Application for Certificate of Appropriateness

Address of Subject Property: 1168 Clifton Road NE Atlanta GA 30307

1168 Clifton Road, Decatur, Georgia 30307
Supporting Document to COA Application

From: Anastasiya Arina <aa@mararigroup.com>
Sent: Friday, January 13, 2023 9:31 AM
To: Cullison, David
Cc: Bragg, Rachel L.
Subject: Re: 1168 Clifton Rd

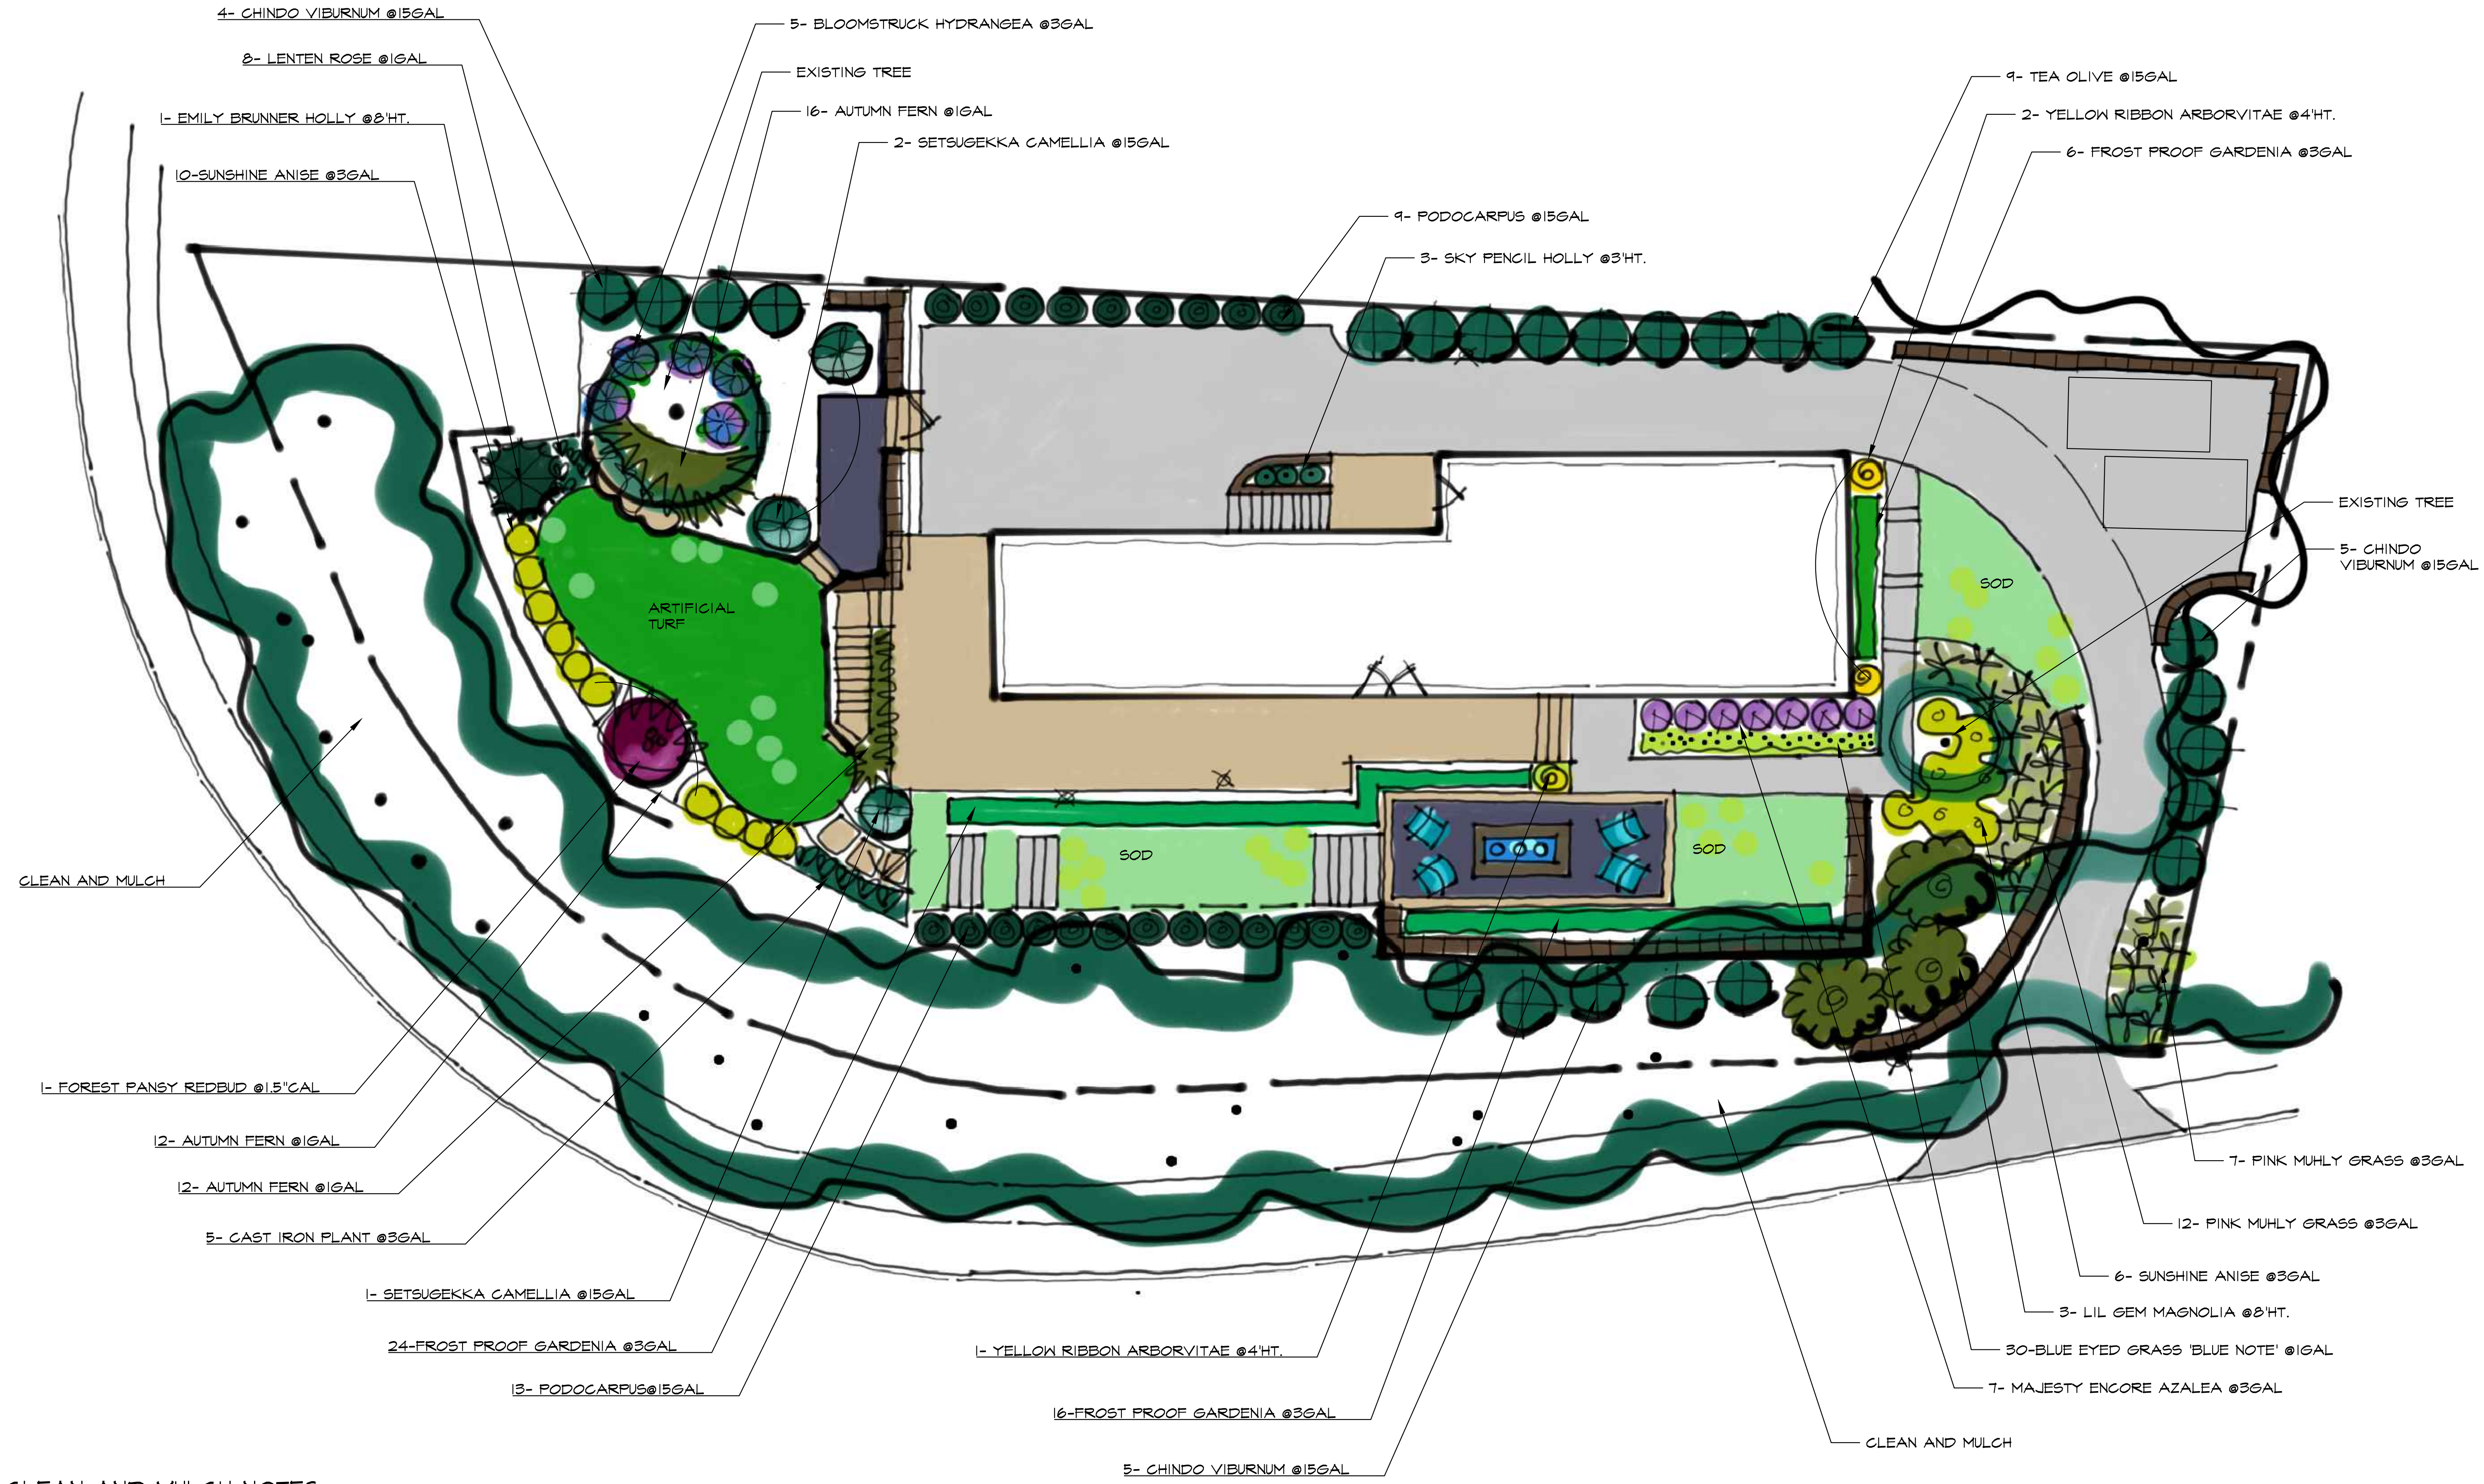
How wide will the driveway apron be?

Will you widen the whole driveway?

6) Existing apron is about 10 feet, we would like to widen to 12 feet if possible. We are only widening a portion of the driveway. I highlighted on site plan below:
